Federal Register

[Docket No. FAA-2022-0891; Project Identifier AD-2022-00585-A,E,R; Amendment 39-22432; AD 2023-09-09]

#### Airworthiness Directives; Various Airplanes, Helicopters, and Engines

**ACTION:** Final rule.

Figure 1 to paragraph (l)(1)(iii) – Inspection Depiction

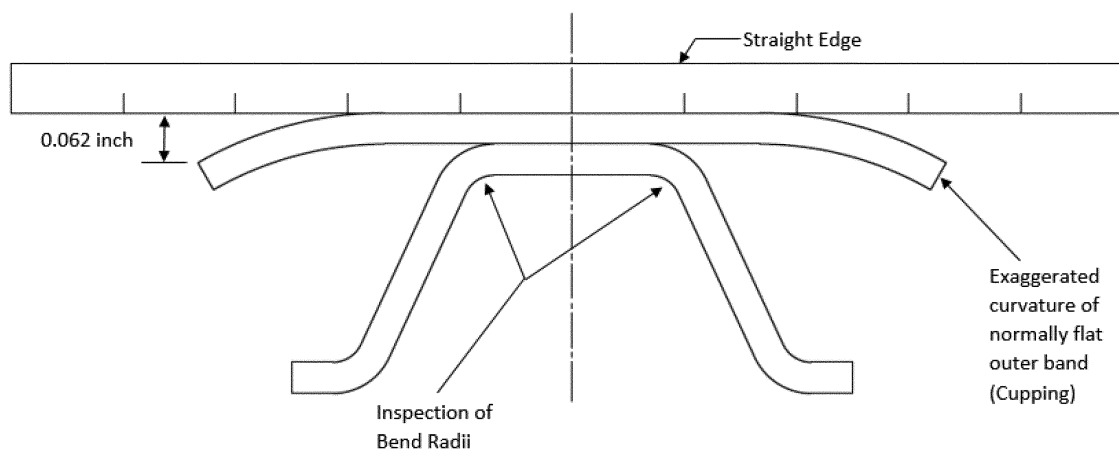
(4) Inspect the v-band coupling outer band for cupping, bowing, and crowning as depicted in figure 1 to paragraph (l)(1)(iii) of this AD. If there is any cupping, bowing, or crowning, before further flight, remove the coupling and, instead of the inspections in paragraphs (k)(5) through (7) of this AD, do the inspections in paragraph (l) of this AD.

(iii) Visually inspect the flatness of the outer band using a straight edge. Lay the straight edge across the width of the outer band as depicted in figure 1 to paragraph (l)(1)(iii) of this AD. If the gap between the outer band and the straight edge exceeds 0.062 inch, before further flight, remove the v-band coupling from service and install a new v-band coupling.

(v) Visually inspect the bend radii of the v-retainer coupling segments, throughout the length of the segment, as depicted in figure 1 to paragraph (l)(1)(iii) of this AD, for cracks. If there are any cracks, before further flight, remove the v-band coupling from service and install a new v-band coupling.
